Ref no: 000115

**Concerning Part Name** : 0603 Series as the following table,

**Product Type** : Chip Inductor

**Classification of Change** : Packing material

Packing Specification

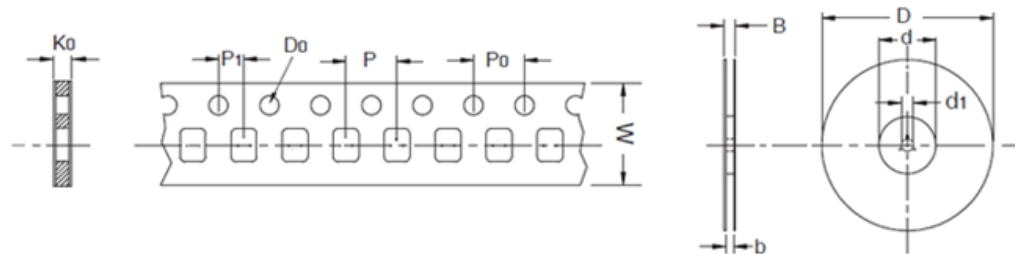
**Description of Change** : Change from embossed plastic to paper carrier tape. Details of paper tape dimensions see below in the table.

**Packing Specification in paper tape:**

Type	Packing Code	D	Do	d	d1	B	b	W	P	P0	P1	Ko	T
0603	01,08	180	1.55	60	13	12.7	8.4	8	4	4	2	0.97	1.05
0603	04	330	1.55	100	13	14.4	8.4	8	4	4	2	0.97	1.05
